Typical In-vacuum RFPD LSC Wiring Chain

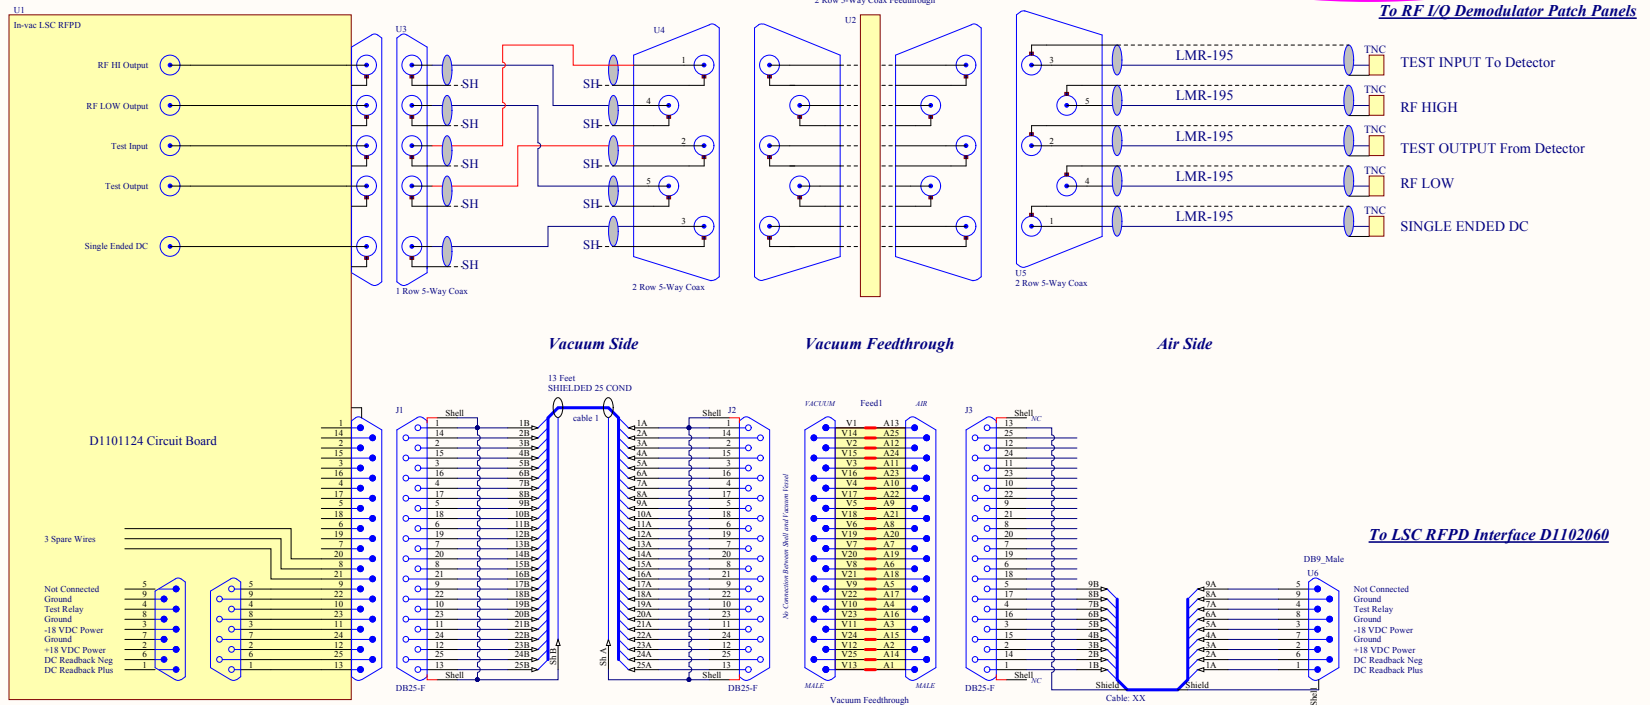
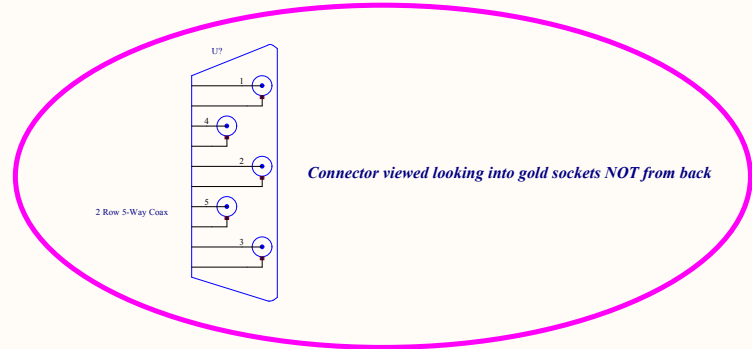
Version 1 - Initial Release
 Version 2 - Revised pinout to reflect the nonsensical way the single row coaxial 5-way D-sub was pinned in another conflicting, but older document.
